**Capacity Development Support  
for CDM Project Implementation:  
Increased Access to Electricity  
Services in Zambia  
and  
Rural Electrification in Bhutan**

Final Report

Japan International Cooperation Agency

Figure B.2: Monitoring organization chart for the project activity

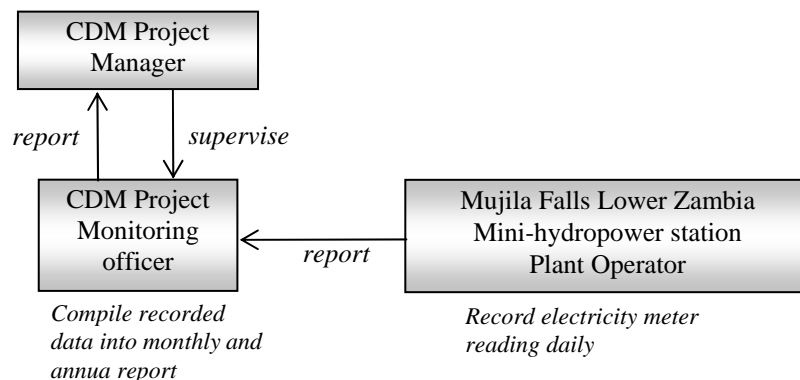
B.7.2 Description of the monitoring plan: Monitoring organization chart	No figure of monitoring organization chart	Figure B.2 for monitoring organization chart is added.	CL-18
C.1.1 Starting date of the project activity	August 2012	28 February 2013	Revised based on the revision of expected date of purchase contract of main equipment
C.2.1.1 The starting date of the first crediting period	01/08/2014	01/03/2015 or the actual starting date of the project operation, whichever is later	“Guidelines on completeness check of request for registration” EB48 Annex60

Figure B.3 Location of monitoring meter

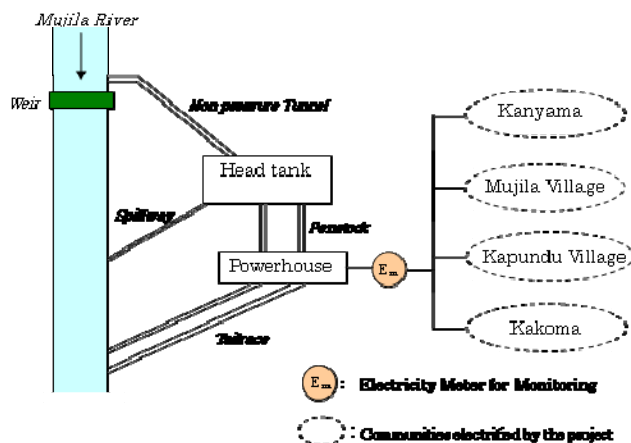
B.6.3 Project emissions	No mention of PE by diesel engine generator	Project emissions taking diesel engine into consideration	CAR-4
B.7.2 Description of the monitoring plan: Location of monitoring meter	No figure of location of monitoring meter	Figure B.3 is added for clarification of location of monitoring meter.	CL-17

33kV T/L MWh meter (E<sub>m</sub>) will record the distributed energy. At the time of electricity meter failure, data log accumulated in the computer at Mujila Power Station will be used as the backup. During normal operation, signals of CT (Current Transformer) and VT (Voltage Transformer) will be sent to both electricity meter and to the computer at Mujila Power Station. Signals sent to the computer are kept as the data log. This data log is the duplicate of the electricity meter readings and can be used to calculate distributed electricity during the event of MWh meter failure. Since CT and VT are not electronic equipment, failure of CT and VT are rarely anticipated.
